**PCN# 20140410000
Design Revision (NBTI Fix for Select TPS40055x Devices)
Change Notification / Sample Request**

PCN Number:	20140410000		PCN Date:	04/14/2014
Title:	Design Revision (NBTI Fix for Select TPS40055x Devices)			
Customer Contact:	PCN Manager	Phone:	+1(214)480-6037	Dept: Quality Services
Proposed 1st Ship Date:	07/14/2014	Estimated Sample Availability:		Date provided at sample request
Change Type:				
<input type="checkbox"/> Assembly Site	<input type="checkbox"/> Assembly Process	<input type="checkbox"/> Assembly Materials		
<input checked="" type="checkbox"/> Design	<input type="checkbox"/> Electrical Specification	<input type="checkbox"/> Mechanical Specification		
<input type="checkbox"/> Test Site	<input type="checkbox"/> Packing/Shipping/Labeling	<input type="checkbox"/> Test Process		
<input type="checkbox"/> Wafer Bump Site	<input type="checkbox"/> Wafer Bump Material	<input type="checkbox"/> Wafer Bump Process		
<input type="checkbox"/> Wafer Fab Site	<input type="checkbox"/> Wafer Fab Materials	<input type="checkbox"/> Wafer Fab Process

Sample product shipping label to indicate die rev location (not actual product label)

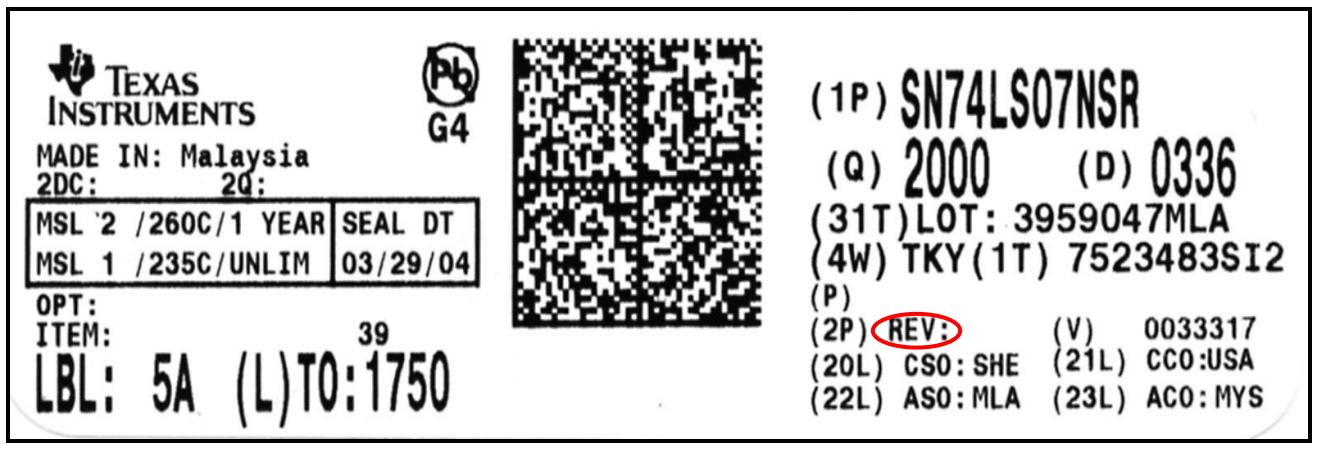
Die Rev designator will change as shown in table & sample label below:

Current	New
Die Rev [2P]	Die Rev [2P]
A	C
